UNITED STATES PATENT AND TRADEMARK OFFICE

APPLICATION NO.	FILING DATE	FIRST NAMED INVENTOR	ATTORNEY DOCKET NO.	CONFIRMATION NO.
10/785,325	02/24/2004	John K. Junkers	2643	9683

Office Action Summary	Application No. 10/785,325	Applicant(s) JUNKERS, JOHN K.	
	Examiner Hadi Shakeri	Art Unit 3723

DETAILED ACTION***Claim Rejections - 35 USC § 112***

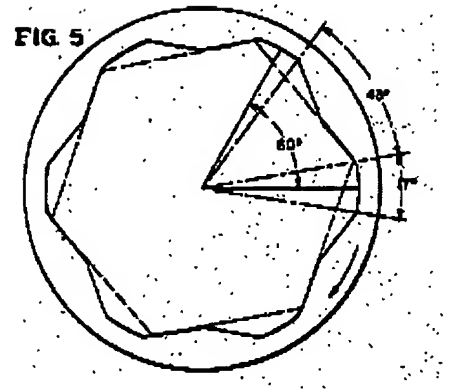
Barnhill, III, et al. discloses all of the limitations of claims 1-4, i.e., a socket having inner opening with six radially outwardly recesses (30) having one flank (11) in the circumferential direction; the recesses forming six radially

inner point (apex) and twelve radially outer points (see Fig. 5) having a radially outer surface (e.g., 40) between the neighboring one of the outer points having a shape substantially corresponding to a shape of a twelve points wherein every other point is removed; and further having another axial portion having means for connecting to a tool,

col. 3, lines 1 and 2.
